# UNITED STATES PATENT AND TRADEMARK OFFICE

APPLICATION NO.	FILING DATE	FIRST NAMED INVENTOR	ATTORNEY DOCKET NO.	CONFIRMATION NO.
09/934,930	08/22/2001	Jugo Mitomo	09792909-5153	8886

**Office Action Summary**

## **DETAILED ACTION**

FIGS. 9A and 9B are perspective sectional views of the device showing the fourth embodiment of the present invention.

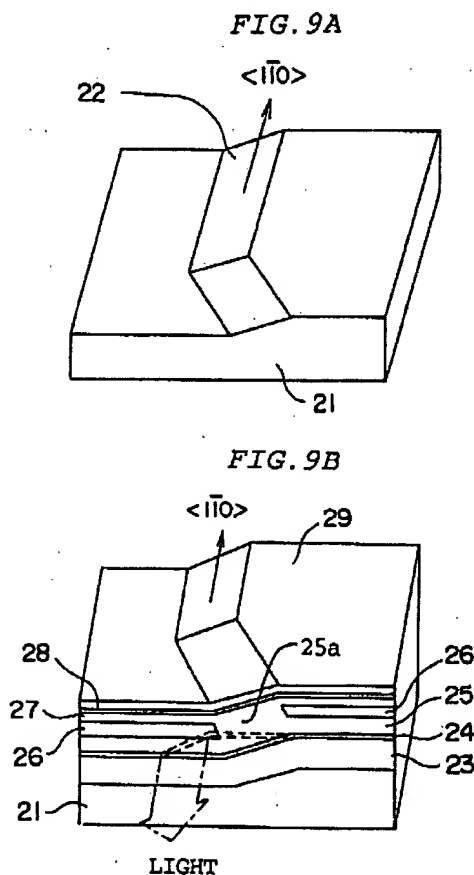
7. Claims 1-18, to the extent understood, are rejected under 35 U.S.C. 102(b) as being anticipated by Furuya (5,568,500). Furuya discloses the claimed invention. Note figures 9A and 9B comprising a substrate (21), a semiconductor stack (23-29), at least one step-like structure (22).

In FIG. 9A, the top of an n-GaAs substrate 21 has a plane tilted by  $6^\circ$  off toward the  $\langle 110 \rangle$  direction from the (001) plane, that is, a plane being by  $6^\circ$  off toward  $\langle 110 \rangle$ . And, a terrace having a mesa-shaped slope 22 with an inclination of approximately  $20^\circ$  is formed on the plane. The slope 22 extends in the  $\langle 110 \rangle$  direction which is the waveguide direction in the central region of the substrate and has a striped shape bent by approximately  $30^\circ$  from the  $\langle 110 \rangle$  direction at the vicinity of the light output edge.

As shown in FIG. 9B, an n-(Al<sub>0.7</sub>Ga<sub>0.3</sub>)InP cladding layer 23, an InGaP active layer 24, and a p-(Al<sub>0.7</sub>Ga<sub>0.3</sub>)InP cladding layer 25 are formed up to the thicknesses of 1, 0.03, and 2  $\mu\text{m}$  respectively according to film deposition by MOVPE on the substrate with the slope 22 formed on it.

For the semiconductor laser with the above structure, the striped active layer 24 on the slope 22 serves as a pumped. However, because the active layer 24 is bent transversely in the vicinity of the output edge, not the active layer 24 but the (AlGaInP) layers 24, 25, and 26 at the side of the layer 24 serve as light output edges.
